# 2 - 72 New Michael Street, Hull

## Type 3 Fire Risk Assessment

Prepared for:	Rebecca Franks, Building Safety Manager
Prepared by:	John Askew, Fire Risk Assessor, Holistic Fire Safety
Date:	25/04/2026
Document Reference:	HFS.HCC.NewMichaelStreet.FRA.3.0

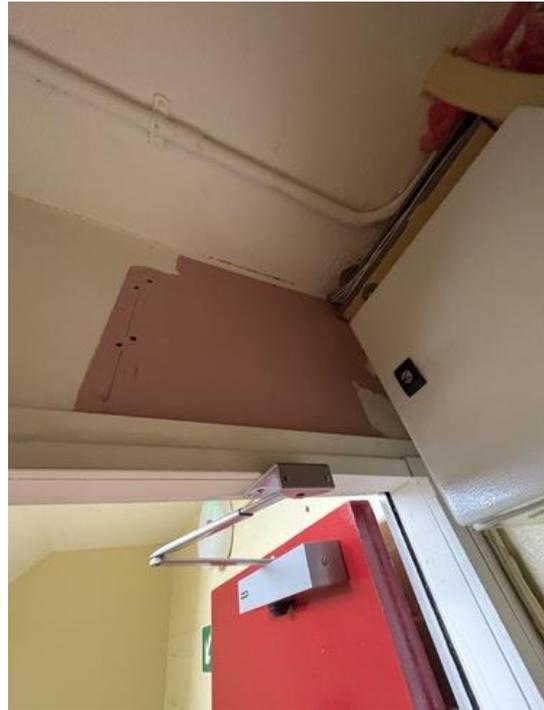
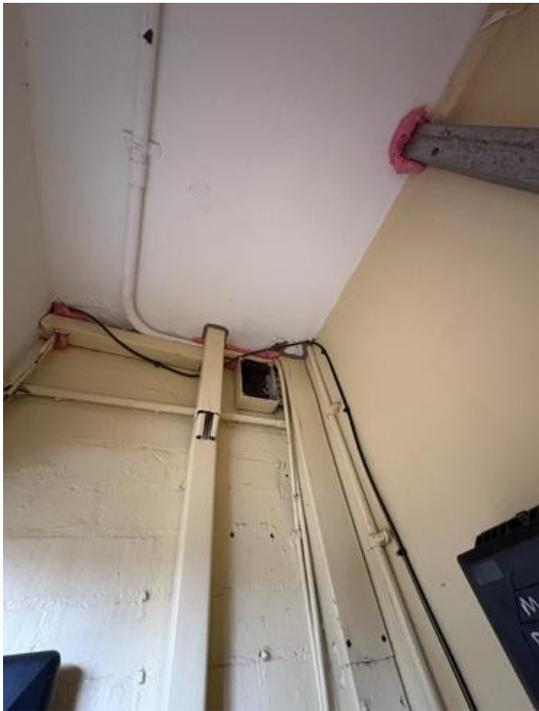
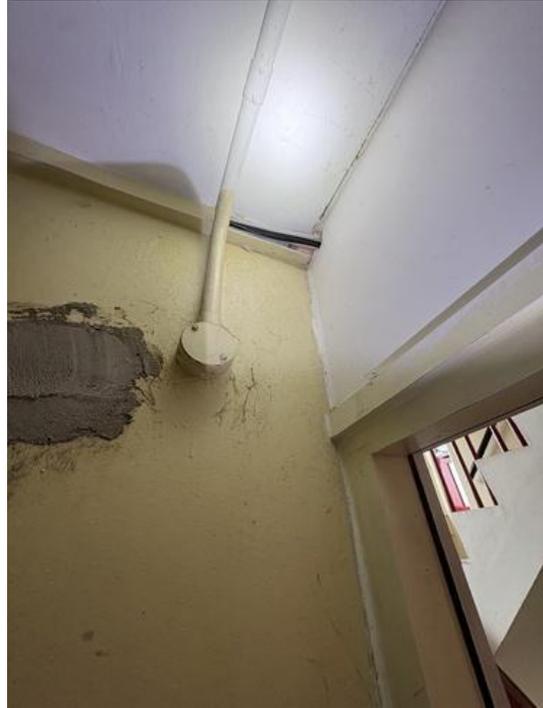
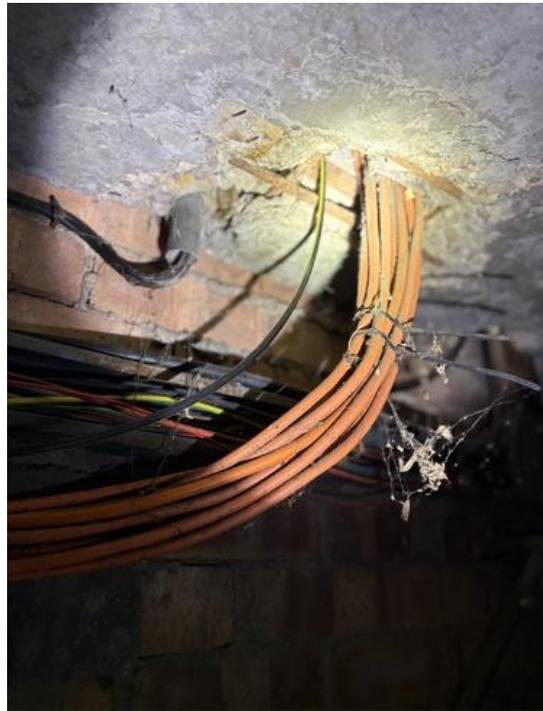
Breaches were present at the point data cables and conduit pass through fire resisting partitions. The majority of these appear to have been fire stopped although there was no test evidence to support this.

Since the previous assessment, communication network cables understood to be installed by a broadband company, have created breaches in compartmentation lines that have not been fire stopped.

Remedial work to fire stop breaches should be undertaken by a competent third-party accredited fire stopping company.

Appoint a competent third-party accredited fire stopping company to carry out fire stopping works.

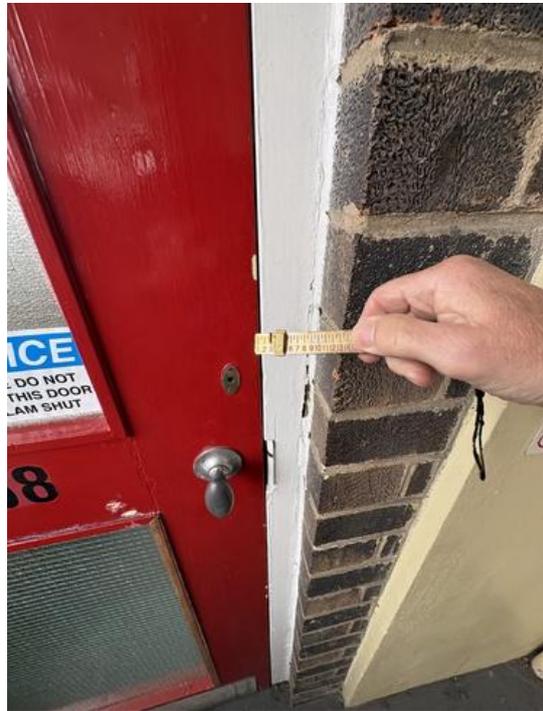
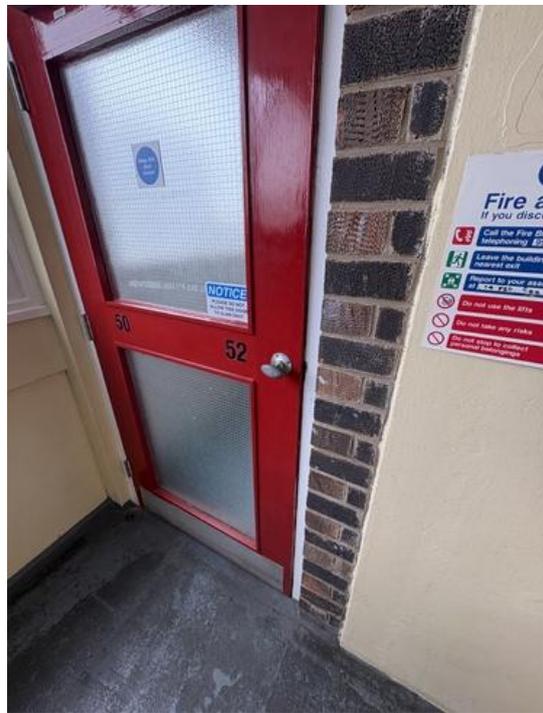
FD06 is damaged and requires replacing. FD19 and FD22 require adjusting as they are not closing fully into their frames.

Replace FD 06.

Ease and adjust FD 19 & FD 22 so they close fully into their frames.
